SUBJECT: Response to Near-Term Bedrock Groundwater Evaluation Work Plan  
JCI/Tyco Stanton (PFAS), 1 Stanton Street, Marinette, WI  
*JCI/Tyco FTC PFAS, 2700 Industrial Parkway South, Marinette, WI\**  
BRRTS #02-38-581955 and #02-38-580694\*  
*\* DNR added this BRRTS case into the tracking of the work plan*

On May 11, 2020 the Wisconsin Department of Natural Resources (DNR) received the *Near-Term Bedrock Groundwater Evaluation Work Plan* ("Bedrock SI Work Plan"), dated May 1, 2020, and submitted by Arcadis U.S., Inc. (Arcadis), on behalf of Johnson Controls, Inc. and Tyco Fire Products LP (JCI/Tyco). The report was accompanied by the appropriate fee of \$700, required under Wisconsin Administrative Code (Wis. Adm. Code) § NR 749.04(1), for formal DNR review and response.

TYCO FIRE PRODUCTS LP MARINETTE, WISCONSIN	
Cross Section A-A' PFOA+PFOS Plume Contours of Recent Sampling Results	
<b>ARCADIS</b>	FIGURE <b>1</b>

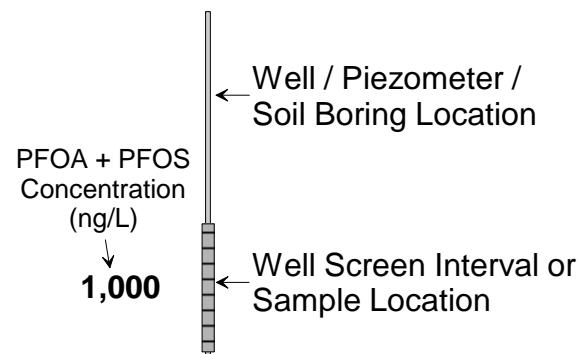
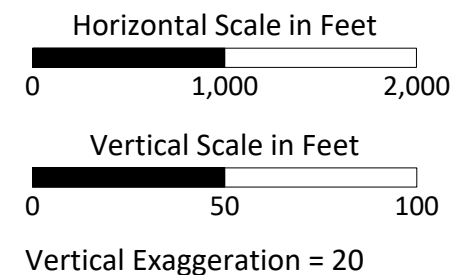
- The bedrock is approximately 35 to 50 feet below ground surface (ft bgs).
- In many locations throughout the area, including on the Stanton property, the bedrock is separated from the unconsolidated aquifer by a low-permeability glacial till (Arcadis' Figures 1, 6 and 7 **Attachment A**). Where present, the glacial till limits the downward migration of groundwater from the upper unconsolidated units into the bedrock.

- In some locations, south and west of the Stanton Site, the low-permeability till is absent; medium to coarse sand and gravel is in contact with the bedrock (Arcadis' Figures 1, 6 and 7 in **Attachment A**). The absence of the low-permeability glacial till allows for a hydraulic connection between the unconsolidated aquifer and the bedrock at these locations.

**FIGURE 1-4**  
 Conceptual Site Model Post-barrier Wall  
 Tyco Fire Products LP  
 Marinette, Wisconsin

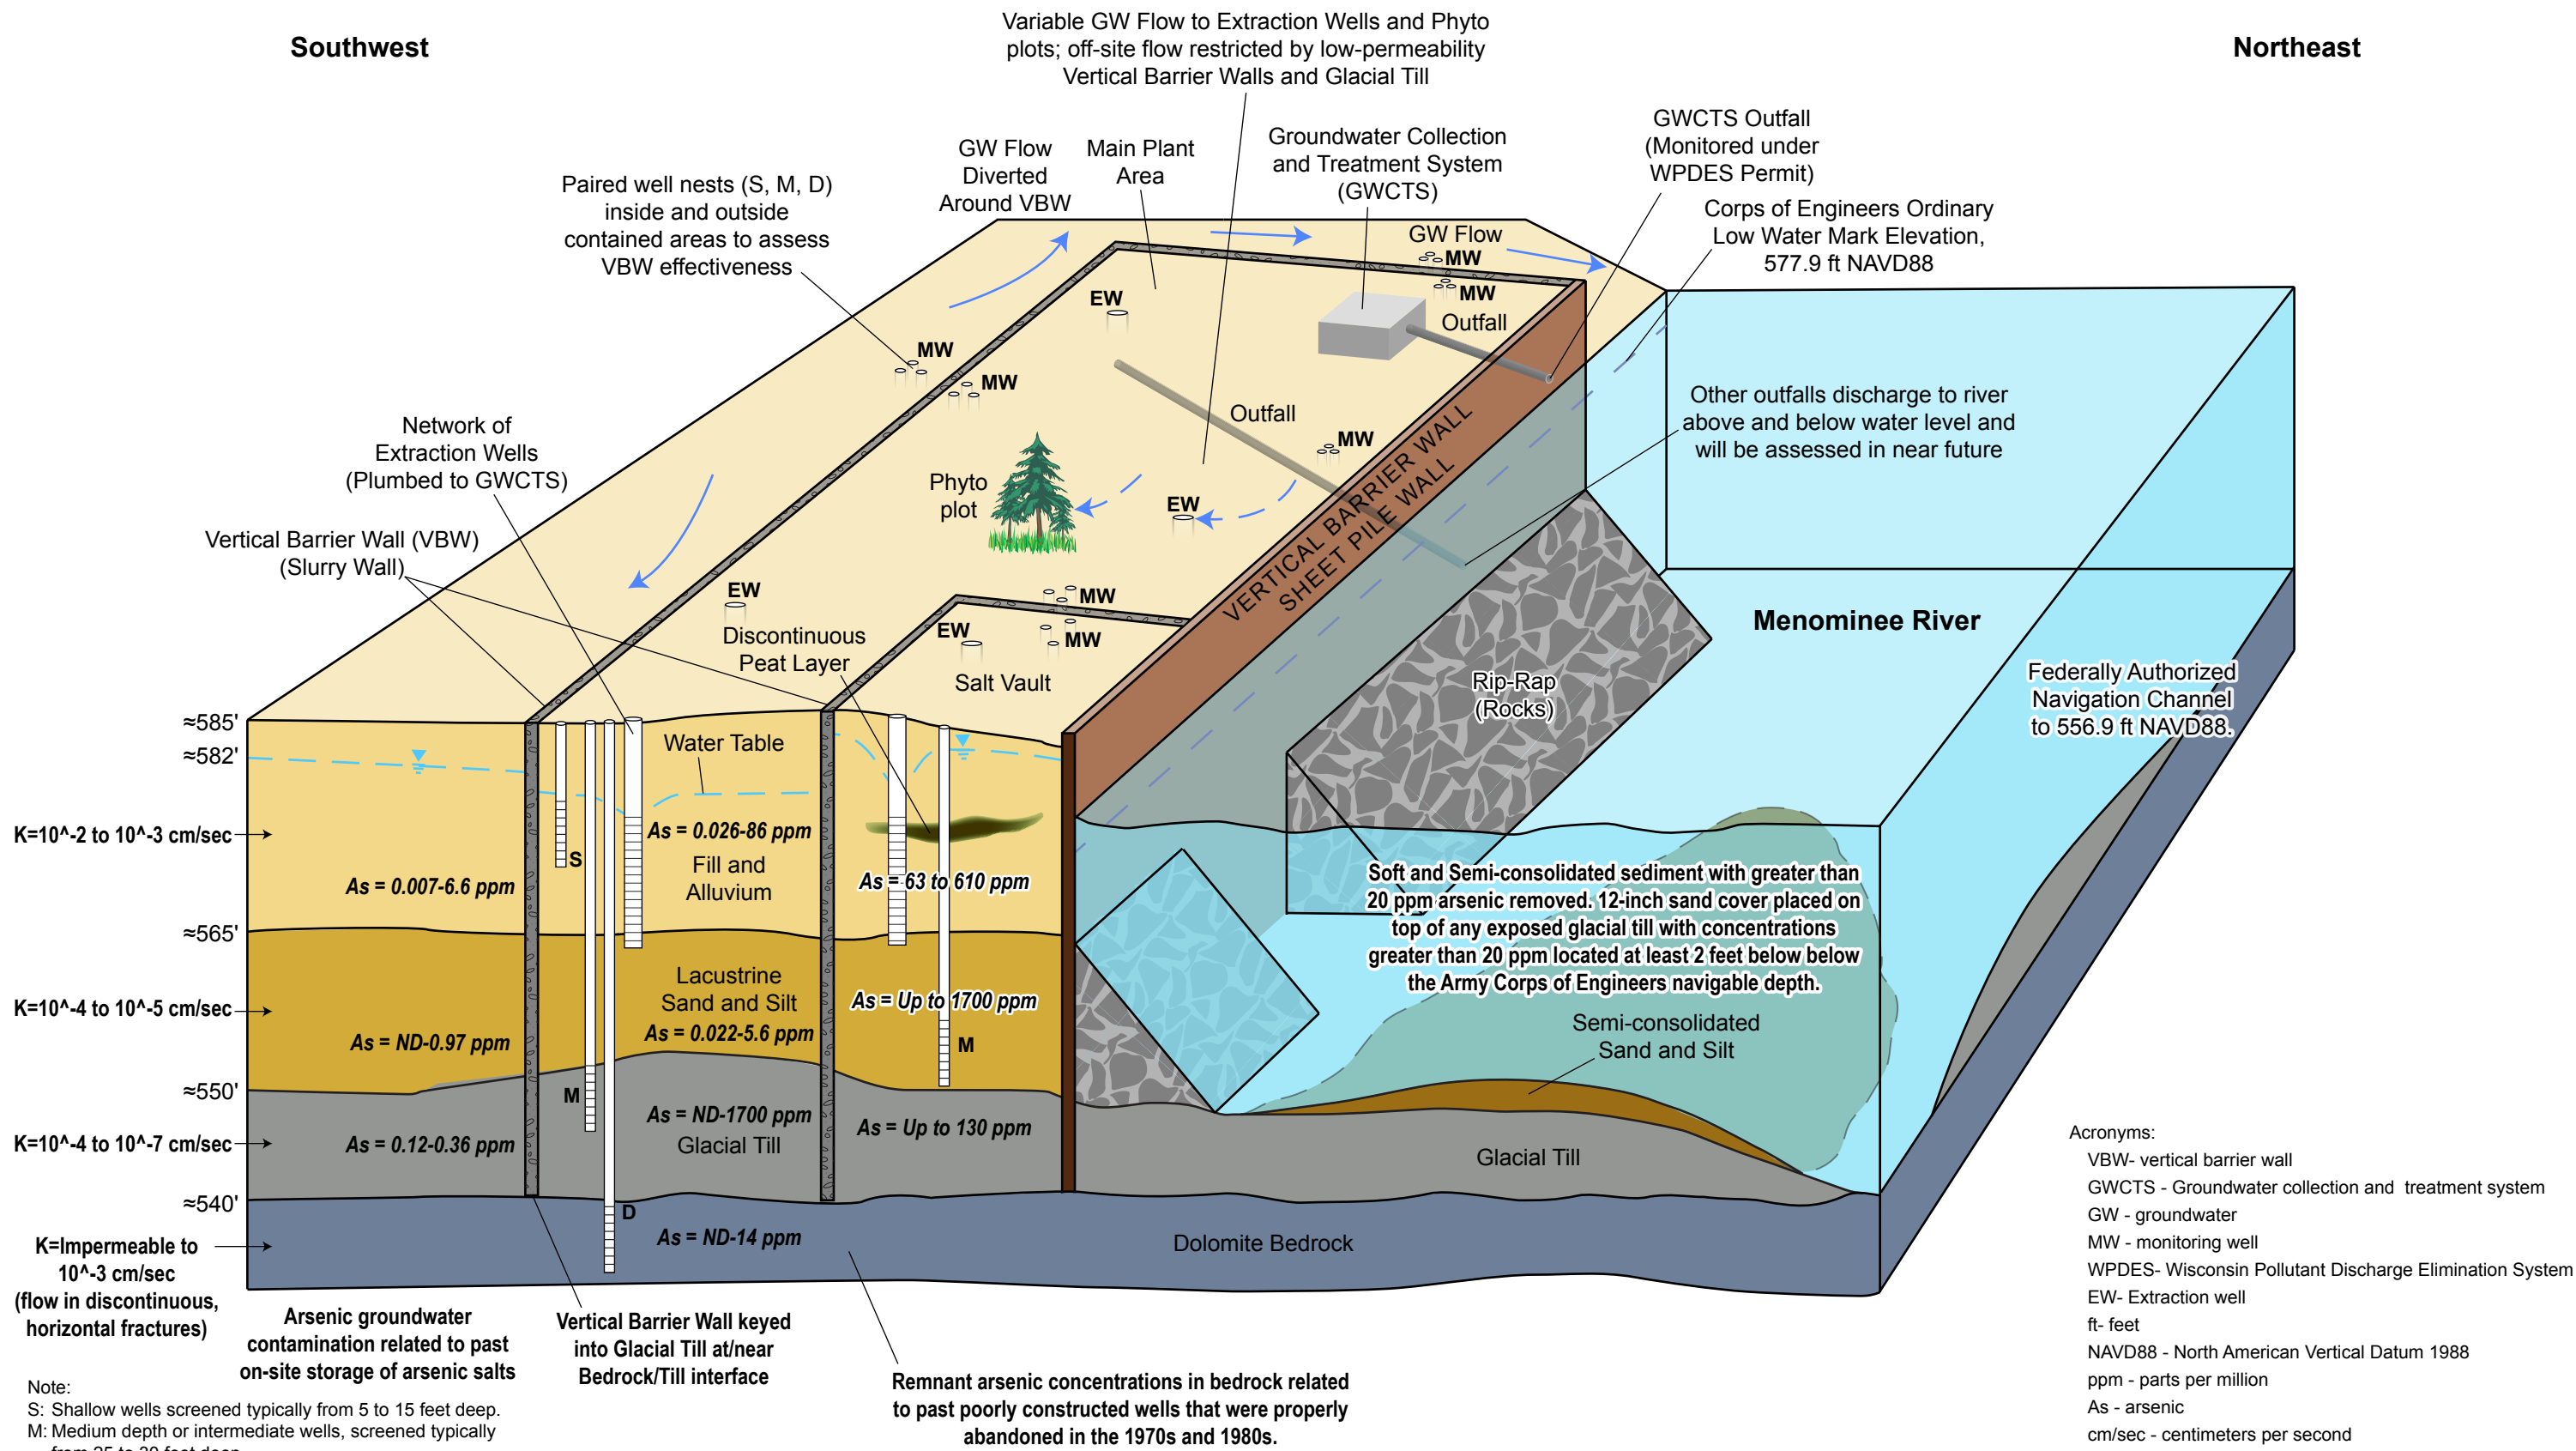
- One of the corrective action measures in place for the arsenic contamination is a groundwater barrier wall that encompasses the Stanton property and that is keyed into the low-permeability glacial till layer that sits on top of the dolomite bedrock (CH2MHill Figure 1-4 in **Attachment A**).

- Flow in bedrock groundwater appears to travel under the barrier wall to the Menominee River.
